From Customer Service Department Subject New third tail light Murciélago

Group 147.08.17

New third tail light Murciélago.

All Murciélago coupè (L147) MY 02-03-04-05-06 until VIN 1900.

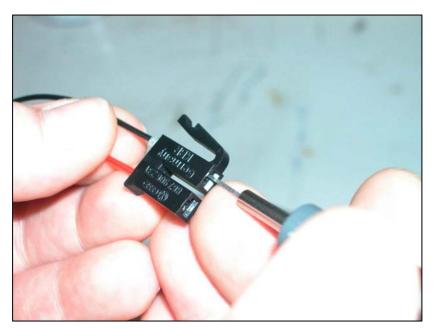
1.4 Disconnect the pins from the connector using the VAS 1978/29 tool, be carefull to avoid damaging the connector. To disconnect the pins you have to lower the pins' tangs.

After disconnecting the pins relift the pins' tangs to allow the following reassemblig.

Pic. 6

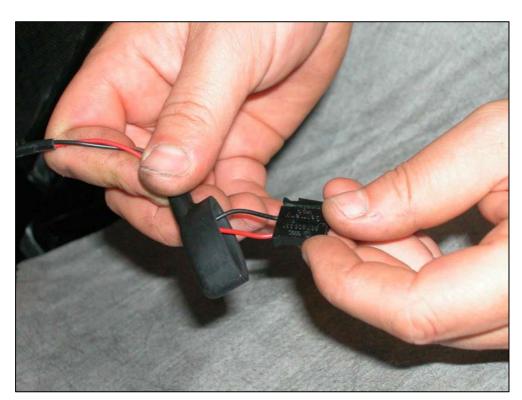
1.6 Insert the rubber protection cap on the wirings (pic.6) and reconnect the wirers with the connector (pic.7).

Pic. 8

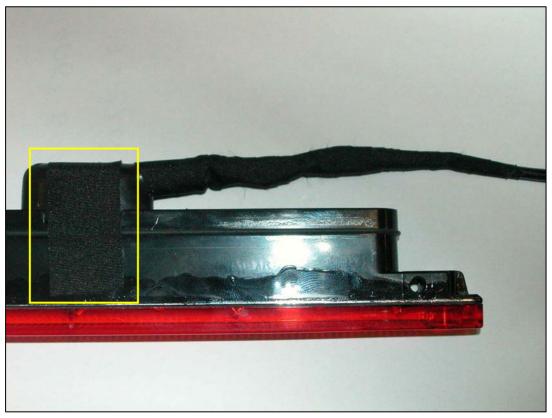
1.7 Carefully cover the wiring (from the end of the shealth) and part of the rubber cap with automotive adhesive tape to avoid water infiltrations.

Pic. 12

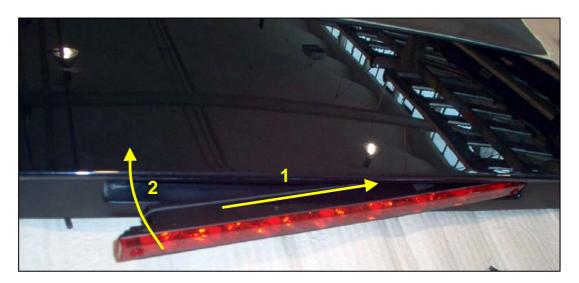
1.9 Insert the lamp back in the spoiler taking care to keep the wiring routing shown in the pictures below. Secure the lamp in the spoiler, following the instructions and assemble order (shown in pic.12).

Pic. 13

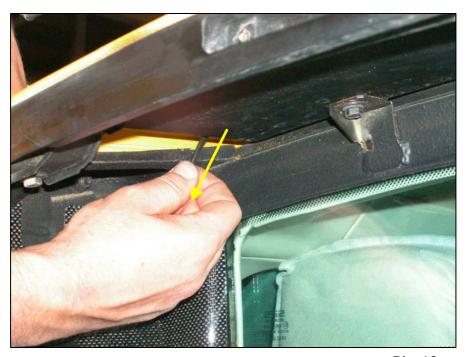
Fix the lamp in the spoiler while pulling the wires (like shown in pic.13) to avoid the excess wiring inside the housing pulls out the lamp.

1.10 Before tightening the lamp securing screws check if the wiring pulls out the lamp, in this case adjust the wiring length like shown in pic.13.
